NORTHERN STATES POWER COMPANY

Monticello Nuclear Generating Plant

REQUEST FOR AUTHORIZATION OF
A CHANGE IN TECHNICAL SPECIFICATIONS
OF APPENDIX A

CHANGE REQUEST DATED FEBRUARY 28, 1974

Figure A-1, Monticello Initial Core Fuel (7x7);
MAPLHGR and PCT vs Exposure

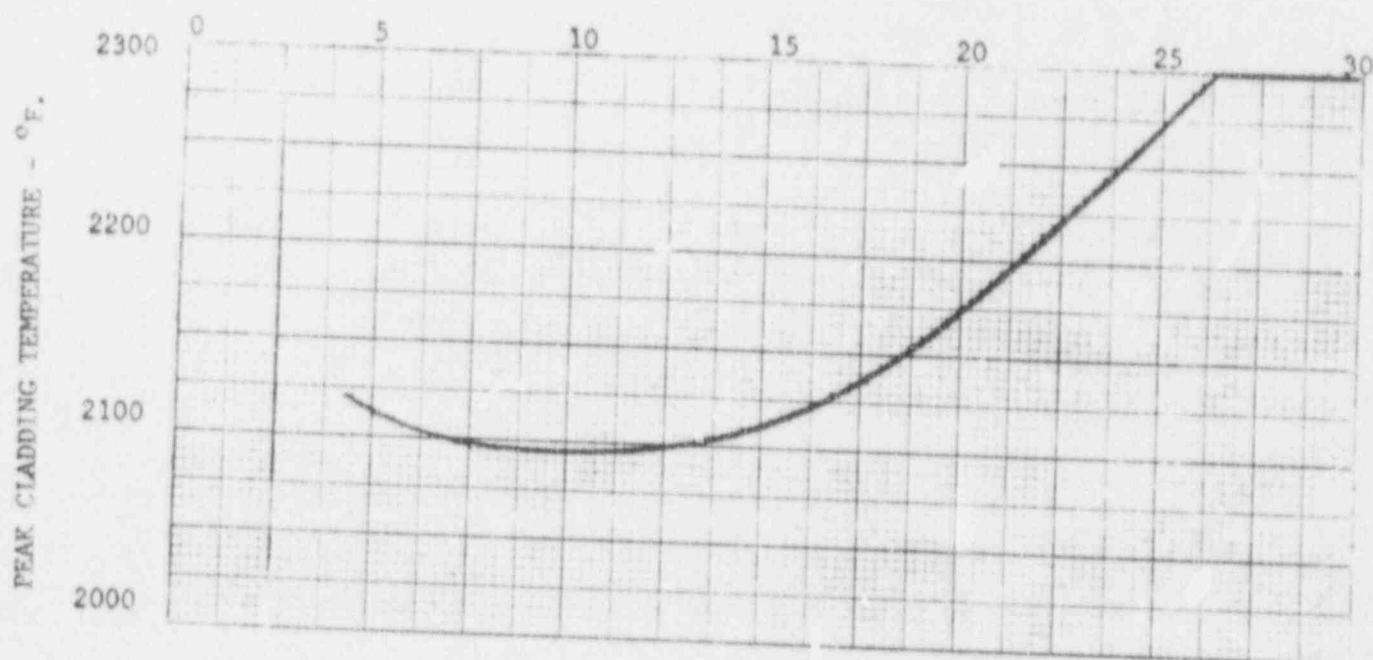
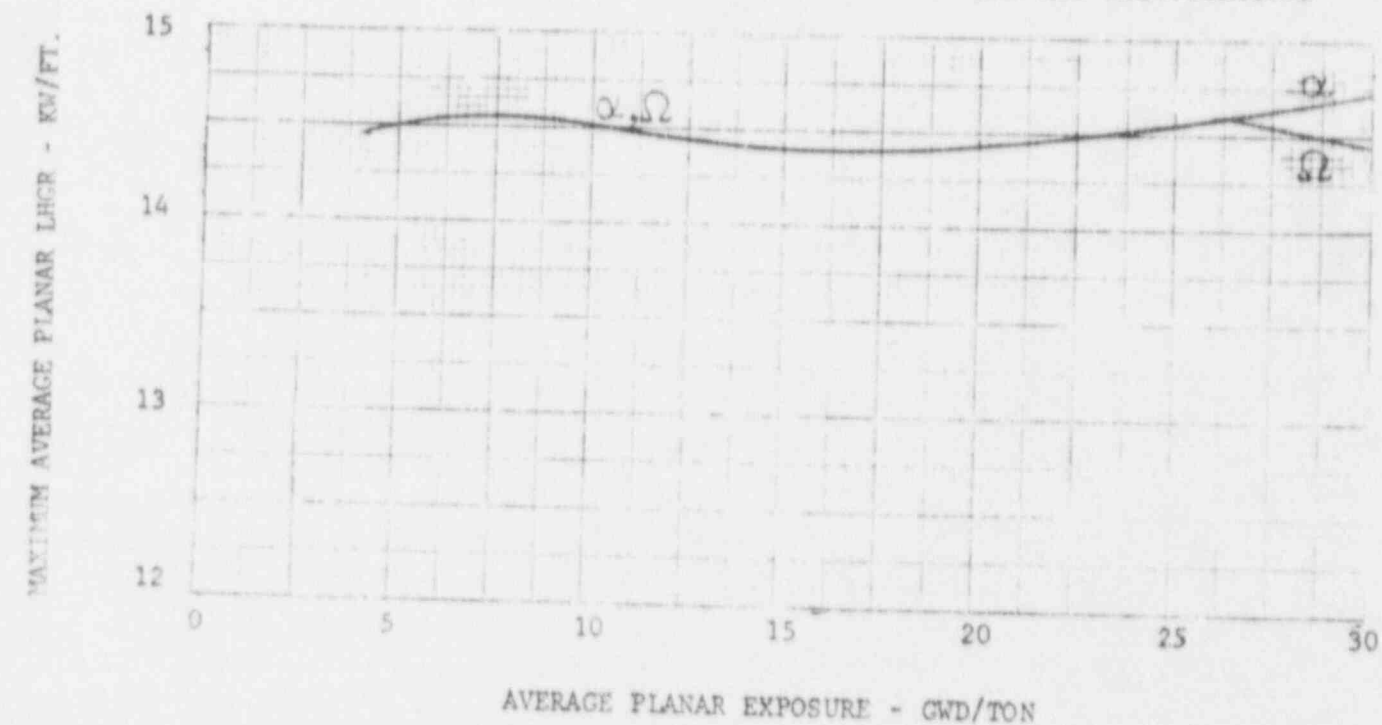
This figure is the result of the recalculation described in Item 1. above. The curves are a composite of two limiting conditions; LHGR for low exposures and peak cladding temperature during LOCA for higher exposures. Figures A-1 through A-3 of this exhibit are included to provide additional information in this regard. The alpha curve shows the MAPLHGR based on design LHGR limitations only. The omega curve is the composite limitation; it becomes more restrictive than the alpha curve when the calculated LOCA peak cladding temperature reaches the current limit of 2300°F.
